Great River Hydro

**Re: Great River Hydro, LLC; FERC Project Nos. 1855, 1892, and 1904
November 30, 2016 through March 22, 2017 Updated Study Report – Response to
Comments**

Great River Hydro Response to November 30, 2016 - March 22, 2017 USR Comments

Study 2-3 – Riverbank Transect and Riverbank Erosion Study

Comment #3 Additional Information:

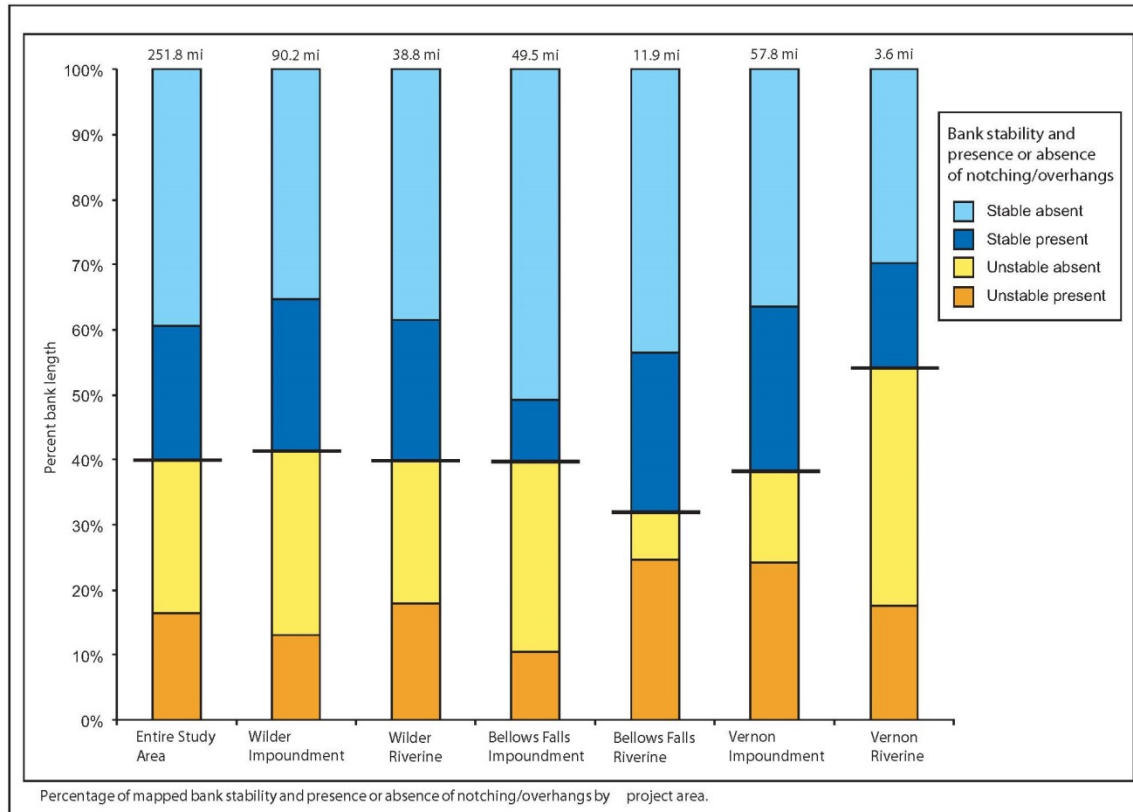
Similar to Figure 5.8-1, this figure presents comparisons of presence and absence of notching/overhangs in areas of stable and unstable banks. The figure illustrates that the amount of notching/overhangs in areas mapped as stable is roughly the same as the amount found in unstable areas and varies by river reach.

Comment #20 Additional Information:

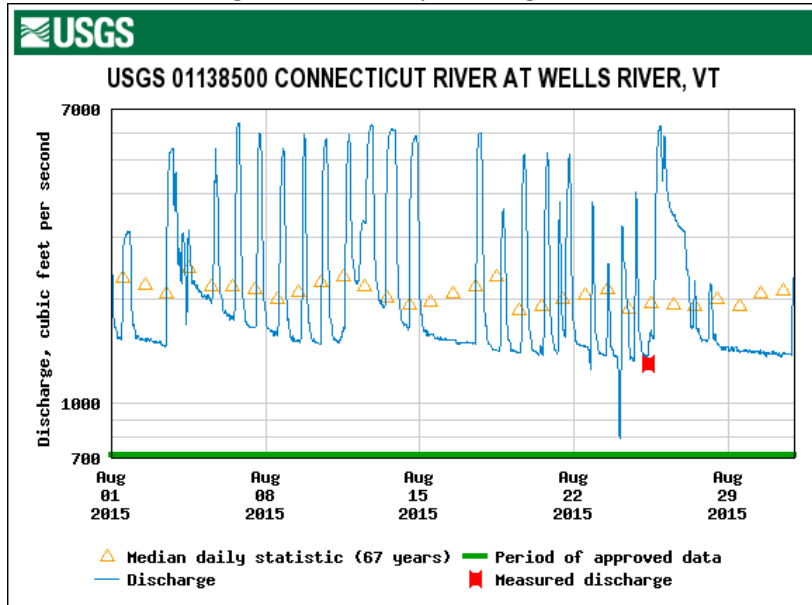
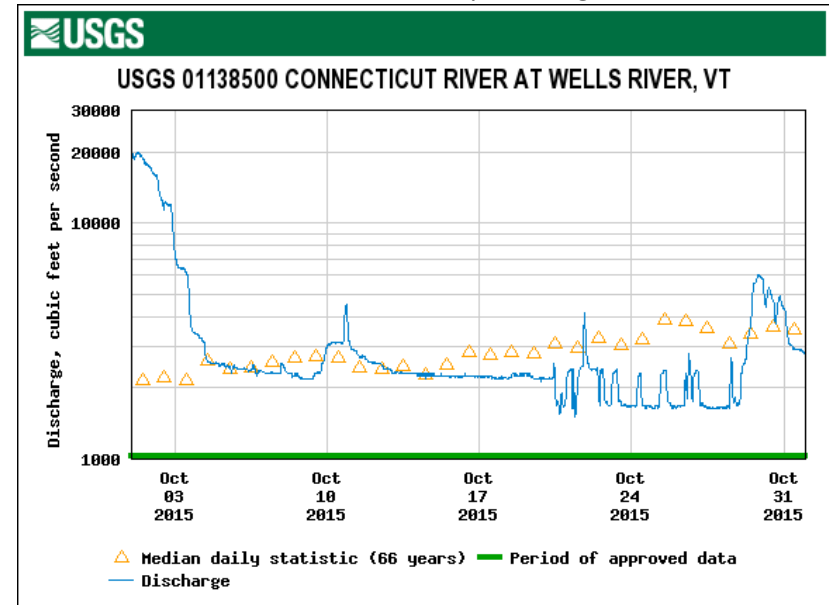
20	CRC	<p>a) Table 4 of Appendix E shows that...median fluctuations between 4 and 7 ft...add up to 36.7 miles of bank.</p> <p>b) [From graphs in the comment letter of water level logger data at the Mudge site and USGS Wells River gage]...show how water levels varied at the Mudge site in August [higher WSE] and October 2015 [lower WSE]. It also appears that midnight is a time when river levels are steeply</p>	<p>a) Higher median fluctuations occur in the uppermost portion of the Wilder impoundment (see Figure 3.4-15 in Exhibit E of the FLAs) and in the riverine reaches downstream of each dam. Note that 36.7 miles of bank equates to only about 10% of the length of all mapped bank.</p> <p>b) It is unclear why the commenter included the USGS graph for the Wells River tributary as mainstem flows are significantly higher than the Wells River. As shown</p>

Comment #	Source	Comment	Response
		<p>rising...</p> <p>c) [Based on the graphs]...the operations of the dams cause river fluctuations that are far from that of a natural river.</p> <p>d) The study report...did not look at periodicity and duration of WSE fluctuations, and shear stresses from project operations have only been looked at for the upper end [of normal operations]. Sub-daily fluctuations will undoubtedly have some effect on bank stability and it may not be entirely due to shear stress.</p>	<p>in the Comment #20 Graphs below, the mainstem gage (Connecticut River at Wells, VT gage #01138500) more clearly illustrates the overall pattern of inflows into the Wilder impoundment (excluding additional inflow from downstream tributaries - Oliverian Brook, Halls Brook, Waits River) and resulting discharges at Wilder dam. Differences in WSE fluctuations in the impoundments are associated both with project operations and changes in inflow. In August 2015, inflows were more variable than in October 2015 (see graphs that follow this study table).</p> <p>c) Note that the baseline for consideration of project effects is not a natural river, but rather the current operations of the projects within the broader context of the managed river.</p> <p>d) See response to Comment #16. Report findings include analysis of sub-daily fluctuations on bank stability.</p>

These figures show discharge at USGS Gage # 01138500 / CONNECTICUT RIVER AT WELLS RIVER, VT which reflect mainstem conditions upstream of the Wilder Project, rather than conditions in the Wells River tributary which were included in the CRC comment letter. The graphs below display the same time periods as the comment letter.
